LR-N08-0043

SALEM GENERATING STATION – UNIT 1 and UNIT 2
FACILITY OPERATING LICENSE NOS. DPR-70 and DPR-75
NRC DOCKET NOS. 50-272 and 50-311

Subject: SUPPLEMENTAL RESPONSE TO NRC GENERIC LETTER (GL) 2004-02, "POTENTIAL IMPACT OF DEBRIS BLOCKAGE ON EMERGENCY RECIRCULATION DURING DESIGN BASIS ACCIDENTS AT PRESSURIZED-WATER REACTORS"

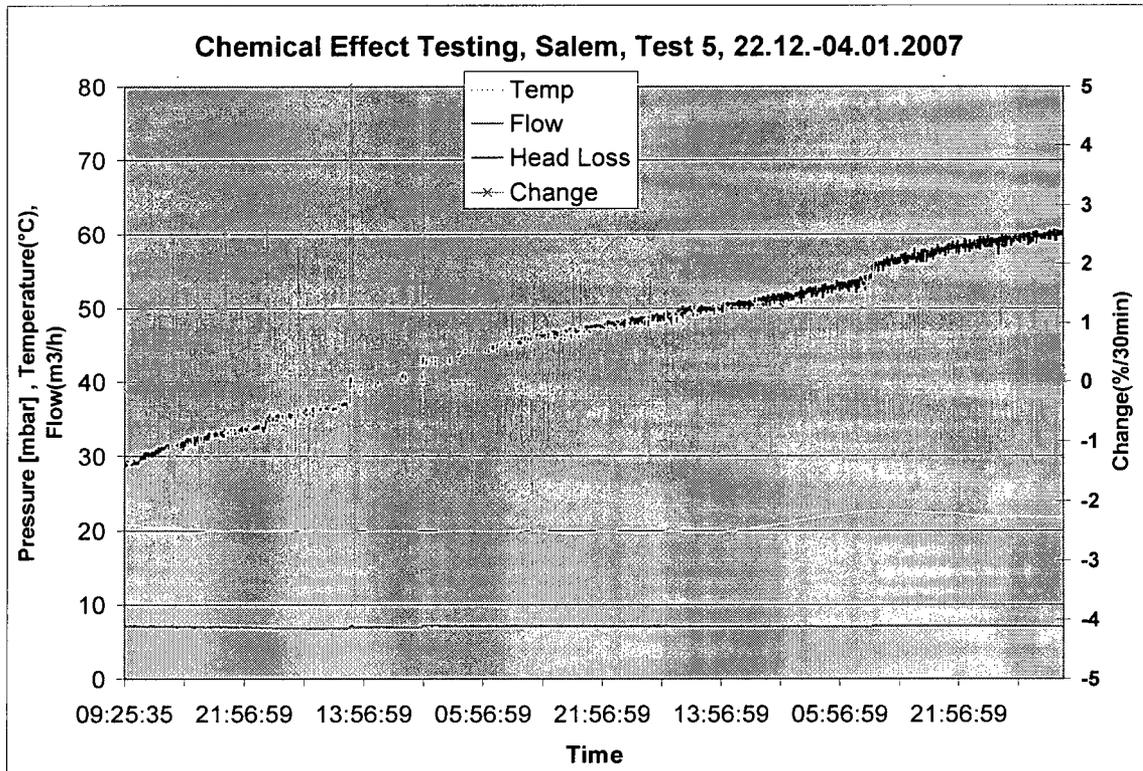
The head loss tests were performed by first filling the MFTL with tap water and borating the loop water. The pH was then checked to be in the 4.5 to 5.5 range and then the debris bed was built. The chemical constituents were then added to generate precipitates in steps of 40%, +30%, +30%, +20%, +20% resulting in ~140% of the total amount of chemical precipitates present in the loop. The loop pH and water temperature are measured throughout the chemical addition process. The pH was maintained at or below 8.4 for 100% or more chemicals. A grab sample was then taken to measure for suspended solids as well as dissolved boron, aluminium, calcium and silica. The extremes for observed water temperature during all testing were: low (12 °C) and high (24°C).

The scaling factors for these tests were 162.5 and 155.1 for Salem Unit 1 and 2 respectively. The flow rates for the tests were scaled from 9000 gpm (two trains) and 5110 gpm (one train) for both Salem Unit 1 and Salem Unit 2.

Diagram 1

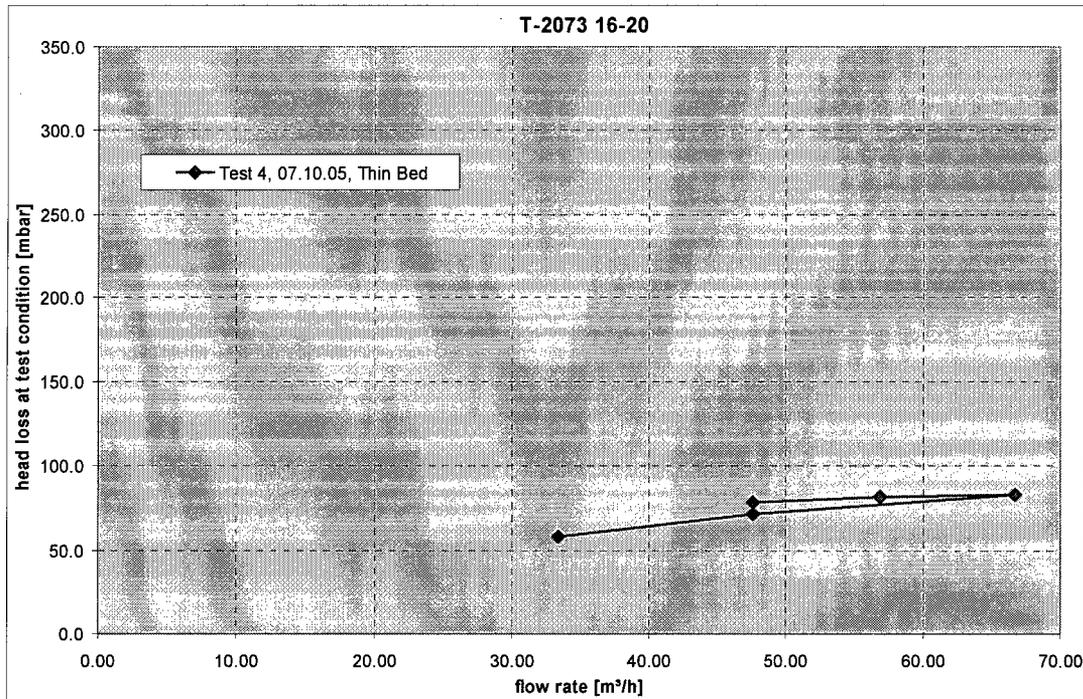
These results show that the screen does not exhibit thin bed behavior.

Figure 5

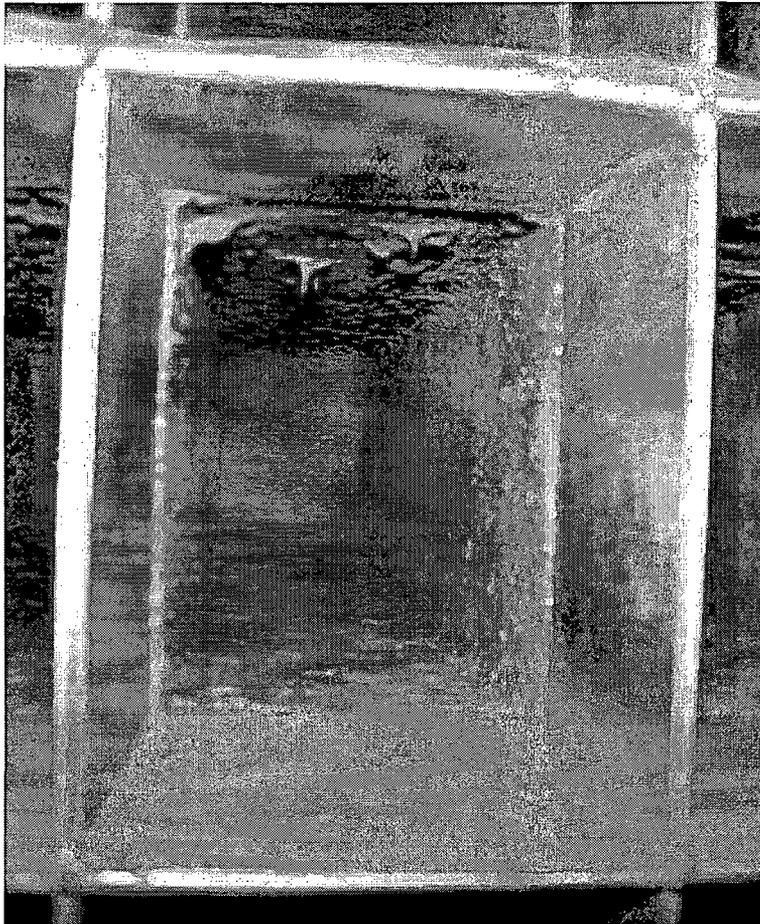
Below, Figure 5 and Figure 6 are from the thin bed testing performed in October 2005 for Salem. The photos were taken after the test conclusion and all water had been drained from the test loop. As can be seen in Figure 6 the drain down process causes some small areas in the debris bed to fall off the top and side strainer surfaces. These open areas do not exist during testing.

Figure 7.

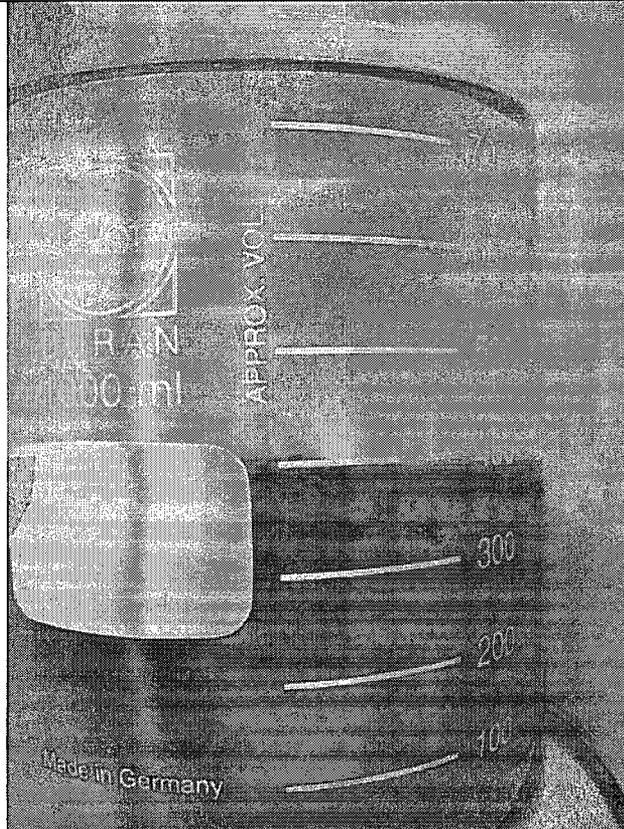
- 1) All NUKON fibers will eventually settle in a zero turbulence environment as described in Figure 7 below. Figure 7 shows a sample 12.5 gram NUKON/500 mL water slurry prepared using the method described in NUREG CR-6917. The slurry in the photo has been undisturbed for approximately 36 hours and no fibers remain in suspension.

Figure 1 Salem Unit 1 Cold Leg Recirculation (w/o Containment Spray)

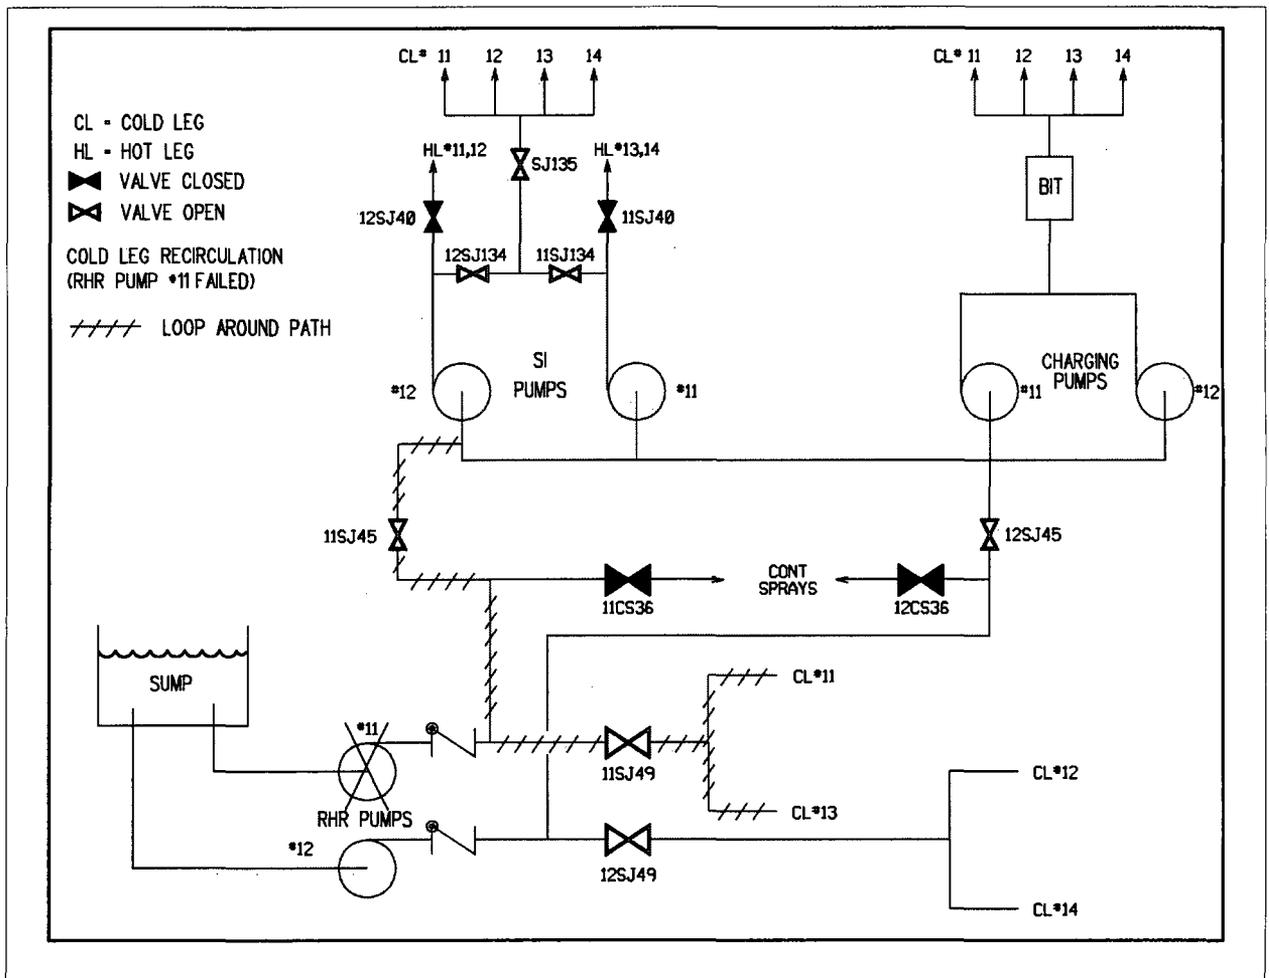
Following loss of one operating RHR pump (example #11 RHR pump) the 12 RHR pump would supply to 12 and 14 cold legs and charging pumps (as previously discussed). In addition a loop around would occur due to the failed RHR pump. The loop around flow path would be, as shown in Figure 1 (below). This configuration results in maximum flow per pump.
